Access Compliance Report

Public Rights-of-Way

(Curb Ramps)

Intersection ID: 28076	Main Street: ALEXANDER MARTIN AV	Cross Street: REA RD	Location: W
ADA ID: 01D5D3EC236B	Ramp Type: Perp	Initial Pass/Fail: Fail	Overall Compliance: No
Severity Score: 33.75			
Codes/Mitigation Info/Possible Solution		Field Measurements/Component Compliance

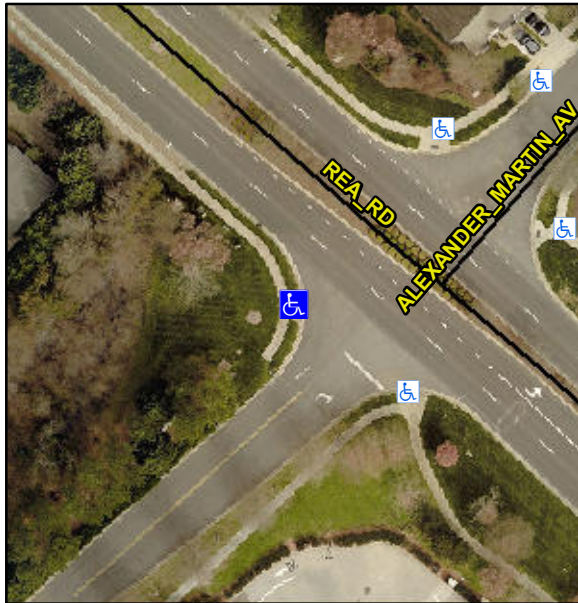
Not Found, R304.5.1, R304.2.2, R304.5.3

Compliance	Description	Data	Compliance	Description	Data
N/A	Ramp Length (in)	72.0	No	Ramp Slope (%)	9.0
No	Ramp Width (in)	46.0	No	Ramp XSlope (%)	5.4
N/A	Flare Type LT	N/A	N/A	Flare Type RT	N/A
N/A	Flare Slope LT (%)	N/A	N/A	Flare Slope RT (%)	N/A
N/A	Flare Traversable LT?	N/A	N/A	Flare Traversable RT?	N/A
N/A	Landing Length (in)	N/A	N/A	DWS Provided?	N/A
N/A	Landing Width (in)	N/A	N/A	DWS Contrast?	N/A
N/A	Landing Slope (%)	N/A	N/A	DWS Length (in)	N/A
N/A	Landing X Slope (%)	N/A	N/A	DWS Full Width?	N/A
N/A	Landing Curb? (Y/N)	N/A	N/A	DWS Offset (in)	N/A
N/A	Shared Landing?	N/A			
N/A	Gutter Ponding?	N/A	N/A	Gutter Slope (%)	N/A
N/A	Gutter Lip Ht (in)	N/A	N/A	Gutter X Slope (%)	N/A
N/A	Painted X Walk1?	No	N/A	Painted X Walk2?	N/A
	X Walk 1 Direction	To SE		X Walk 2 Direction	N/A
N/A	X Walk 1 Width (in)	N/A	N/A	X Walk 2 Width (in)	N/A
	X Walk 1 Slope (%)	0.5		X Walk 2 Slope (%)	N/A
	X Walk 1 X Slope (%)	0.4		X Walk 2 X Slope (%)	N/A

Remove & Replace Entire Ramp.
